January 4, 2022.

Re: Ministry of Transportation and Infrastructure (MoTI) File 2021-05737 - Zincton Farms Ltd. Formal Proposal. Request for Crown tenure north of Highway 31A, between Kaslo and New Denver.

Attn: Zoran Boskovic and Barb Wheatley
Mountain Resorts Branch
Ministry of Forests, Lands, Natural Resources and Rural Development

Figure 1. Highway 31A avalanche paths. Ministry of Transportation and Infrastructure.

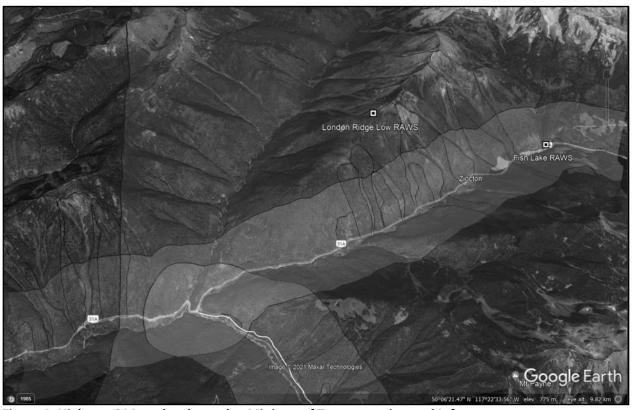
For 33 years, professionals with the Ministry's <u>Avalanche Safety Program</u> have managed nine distinct avalanche paths within the proposed Crown tenure that directly impact the Highway 31A corridor. MoTI seeks to minimize the frequency and duration of avalanche-related road closures, while ensuring the safety of the travelling public.

Figure 2. Map of proposed tenure with avalanche path overlay. Ministry of Transportation and Infrastructure.

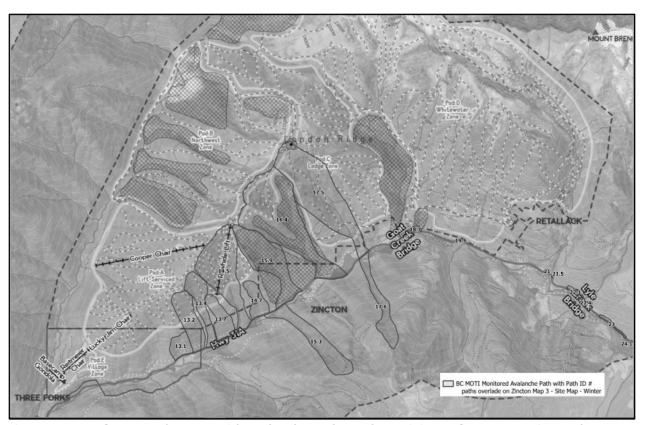
Mapping of the proposed tenure area in the Zincton Farms Formal Proposal includes 2 chair lifts, a Backcountry Lodge, Emergency Huts and Potential Ski Zones (Figures 3.2, 4.2, 4.3a, 4.3b, 4.4, 4.5), that overlay existing avalanche paths, avalanche start zones, current and potential hazard areas. In addition, landscape changes over time (for example due to fire or slope movement) could increase hazards and avalanche potential, and physically increase areas of concern within or near the proposed tenure.

It is critical that a formal, quantitative analysis of the proposal and snow avalanche risk assessment to the Highway 31A corridor is undertaken prior to further consideration of the application.
